## **DEVELOPMENT APPLICATION ACCESS REVIEW**

## **PROPOSED JUNIOR SCHOOL PHASE 1**

St Philips Chistian College Gosford Campus  
Narara Creek Road  
NARARA NSW

Report prepared for:	St Philips Christian College c/- Ian Easton Architect 112 The Lane WICKHAM 2293
Report prepared by:	Lindsay Perry Philip Chun Access Pty Ltd Suite 404, 44 Hampden Road ARTARMON NSW 2064
Report No:	AN15-205523 20150904 DAR_LP.doc
Date:	04 September 2015

ENTRY LEVEL  
438-S10

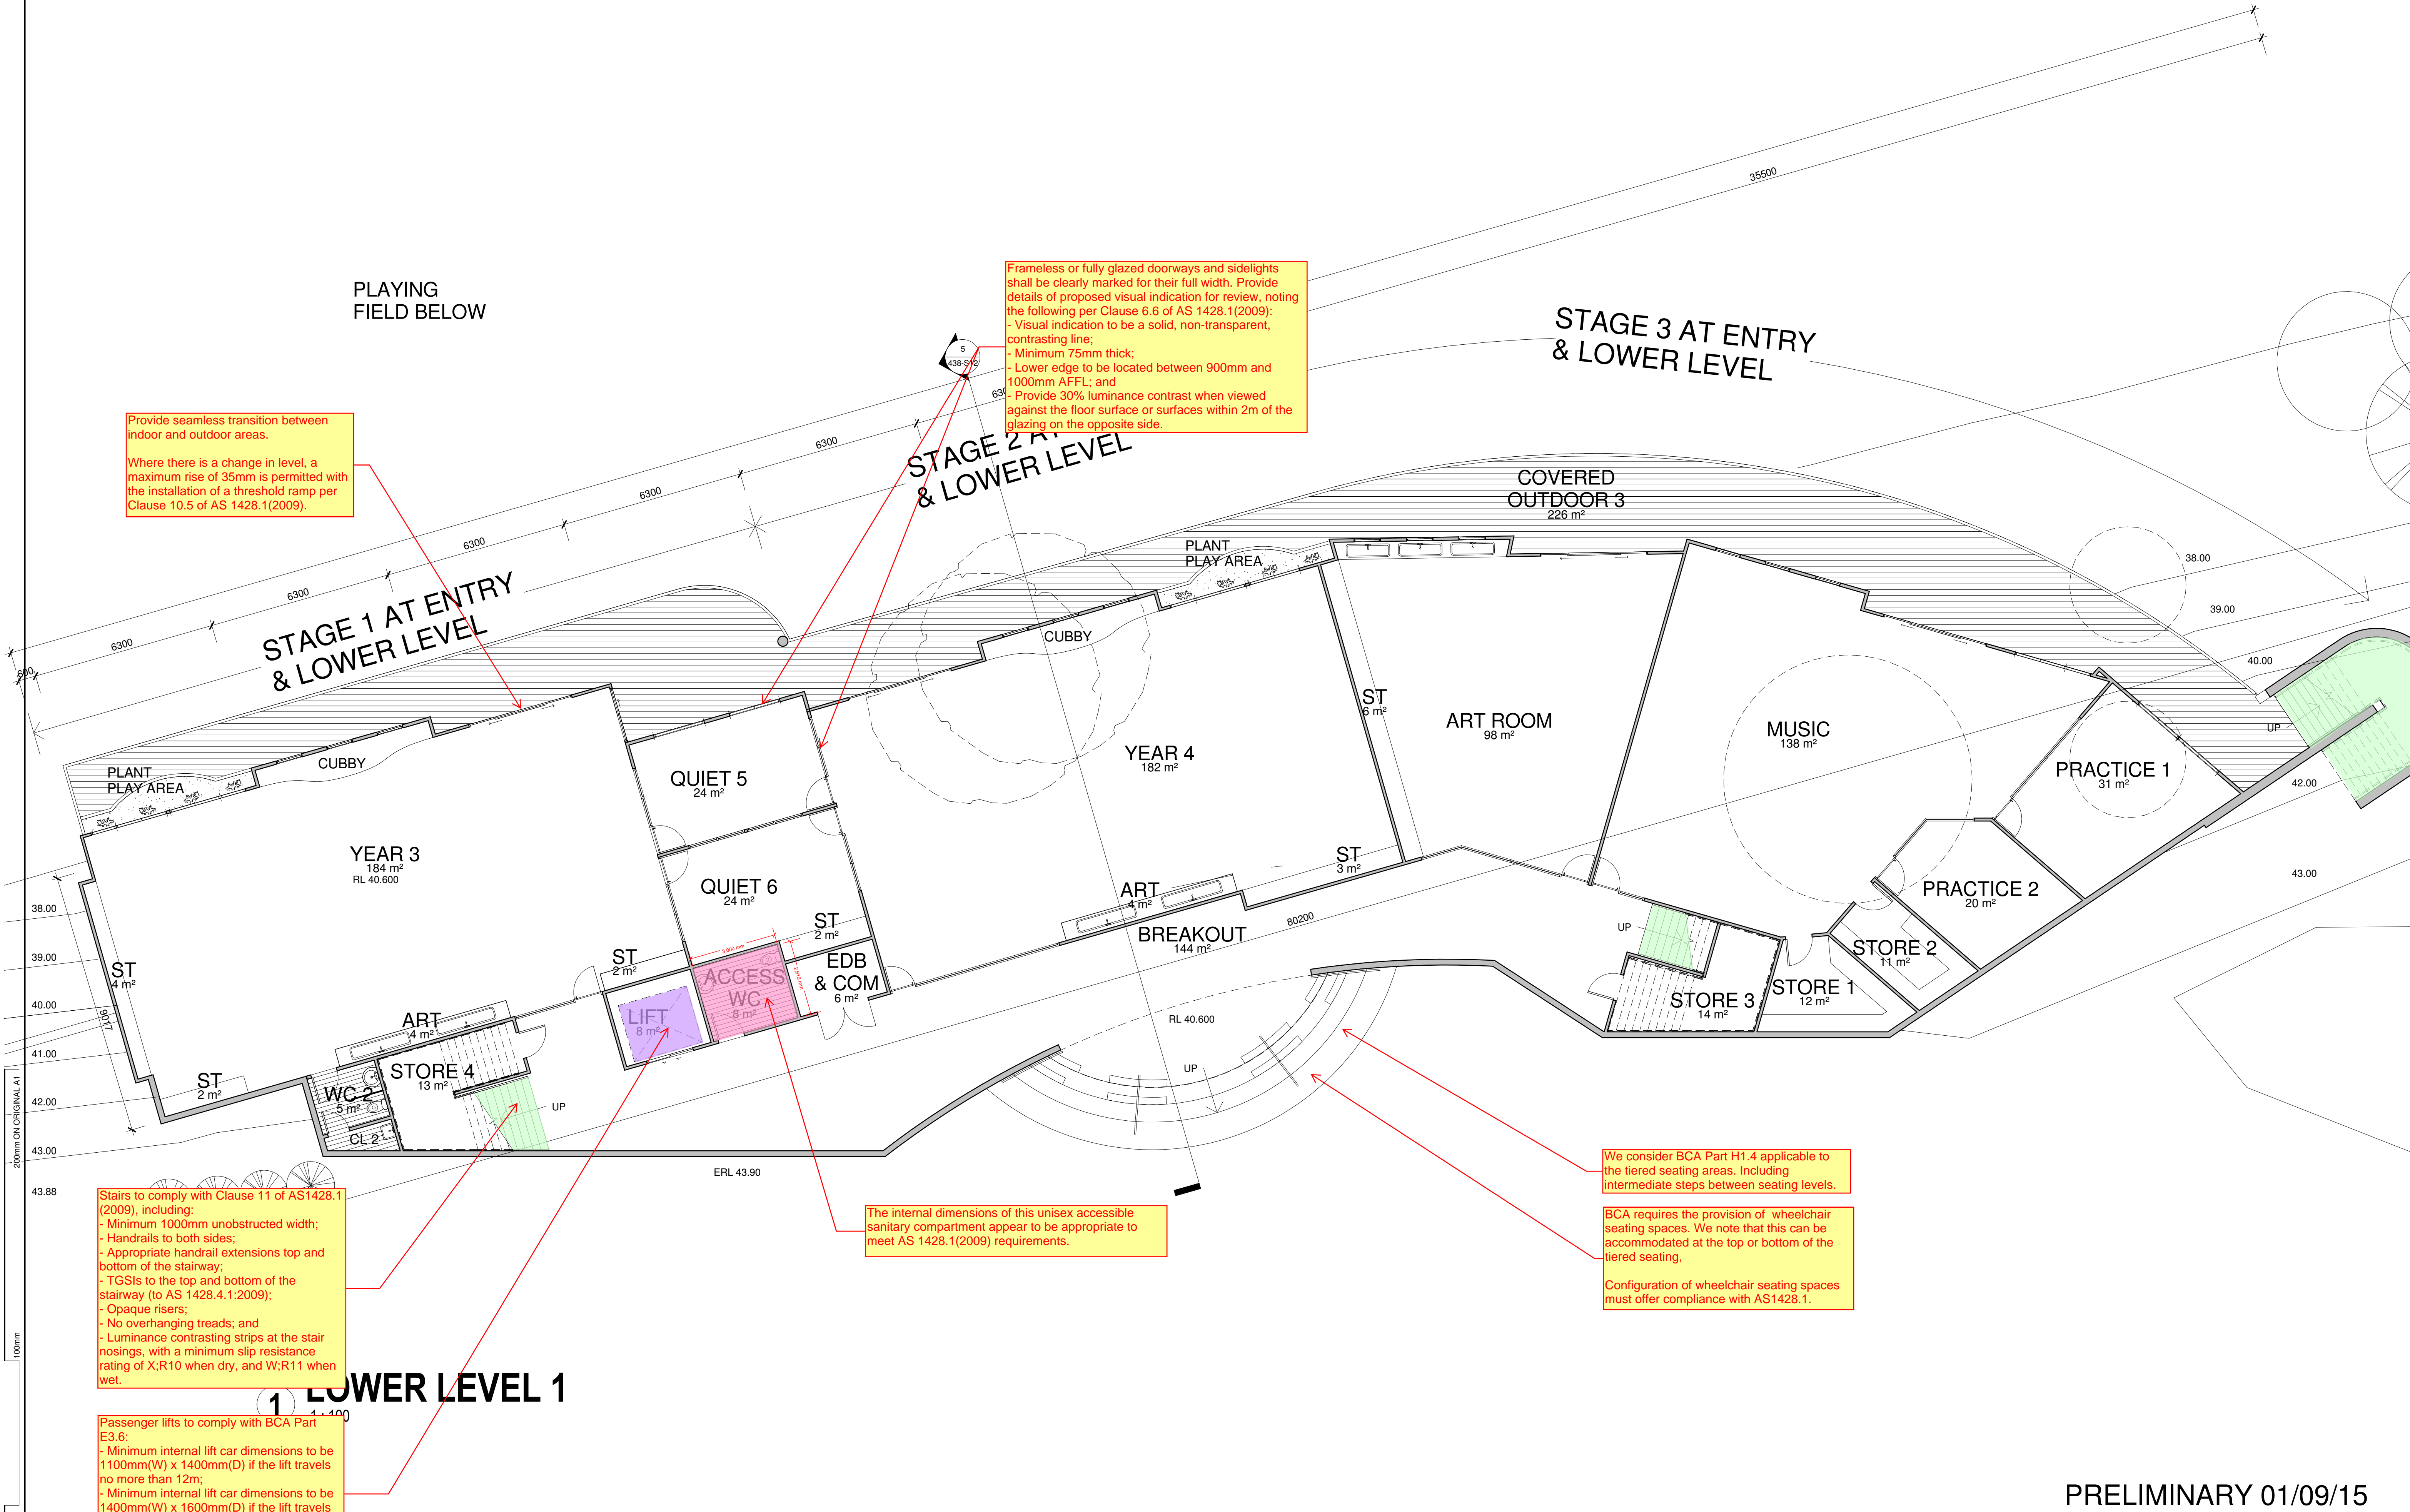
Provide seamless transition between indoor and outdoor areas.

Where there is a change in level, a maximum rise of 35mm is permitted with the installation of a threshold ramp per Clause 10.5 of AS 1428.1(2009).

Frameless or fully glazed doorways and sidelights shall be clearly marked for their full width. Provide details of proposed visual indication for review, noting the following per Clause 6.6 of AS 1428.1(2009):

- Visual indication to be a solid, non-transparent, contrasting line;
- Minimum 75mm thick;
- Lower edge to be located between 900mm and 1000mm AFFL; and
- Provide 30% luminance contrast when viewed against the floor surface or surfaces within 2m of the glazing on the opposite side.

Stairs to comply with Clause 11 of AS1428.1 (2009), including:

Passenger lifts to comply with BCA Part E3.6:

## 1 LOWER LEVEL 1

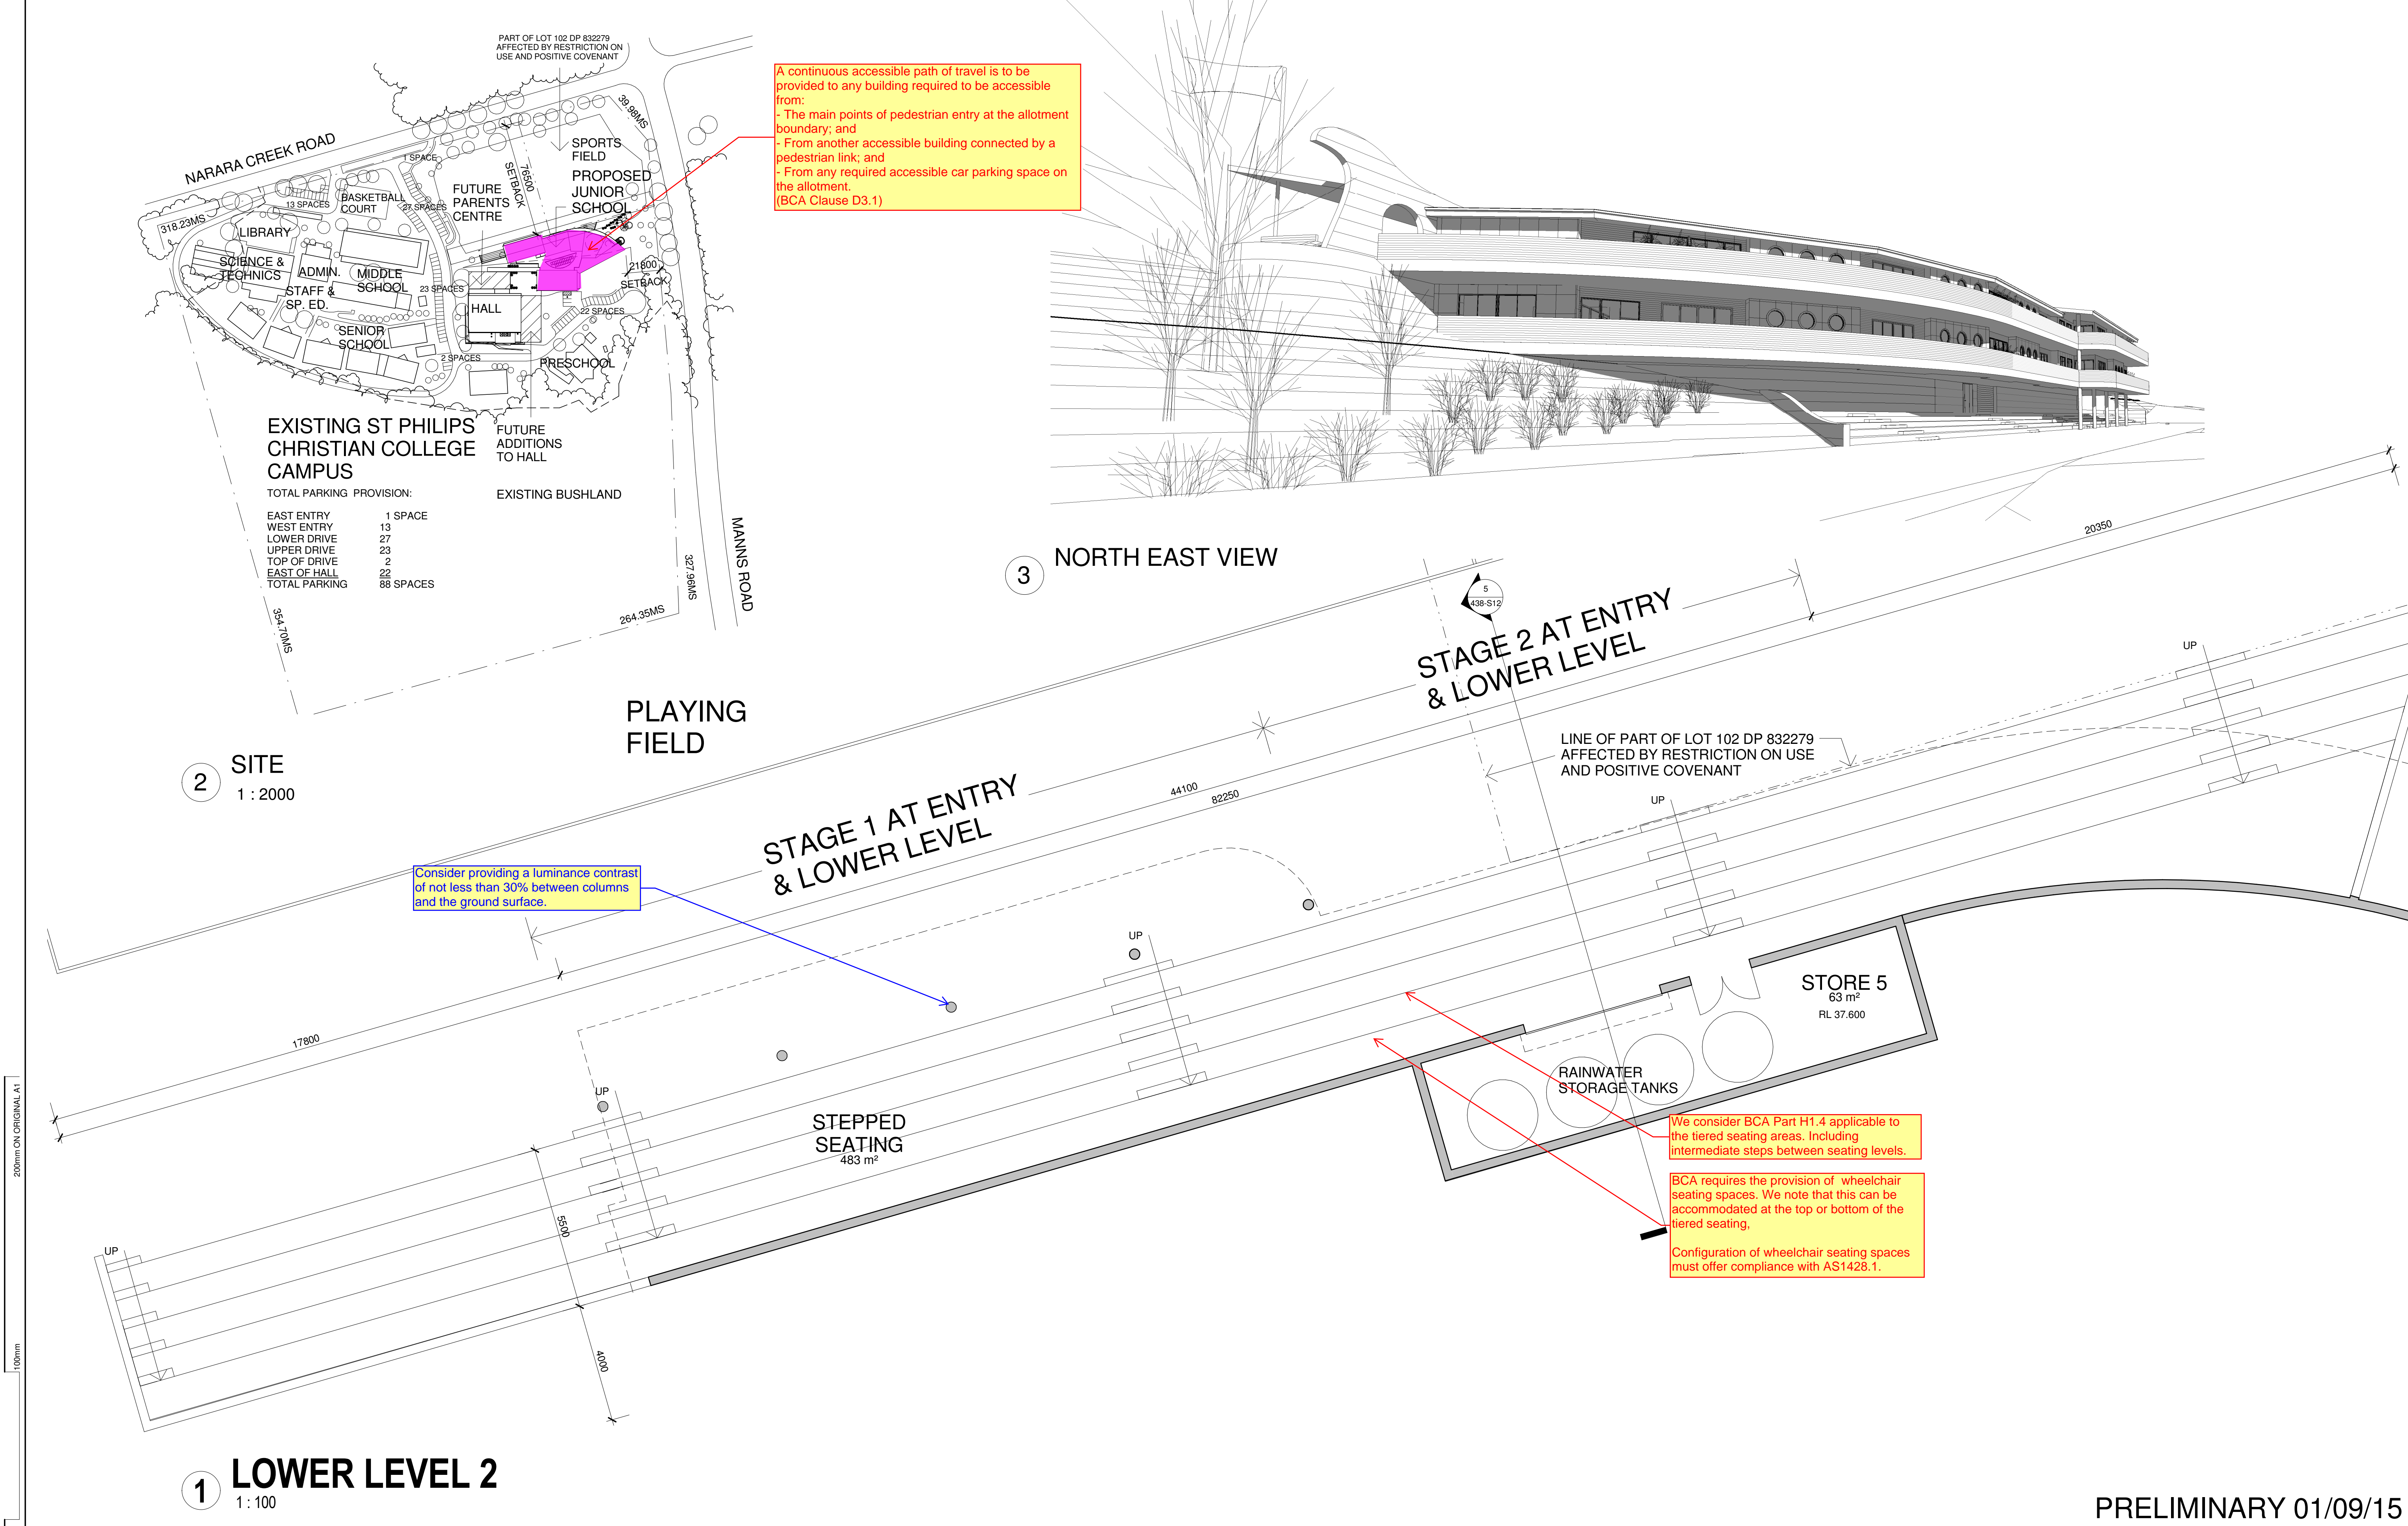
A continuous accessible path of travel is to be provided to any building required to be accessible from:  
- The main points of pedestrian entry at the allotment boundary; and  
- From another accessible building connected by a pedestrian link; and  
- From any required accessible car parking space on the allotment.  
(BCA Clause D3.1)

Consider providing a luminance contrast of not less than 30% between columns and the ground surface.
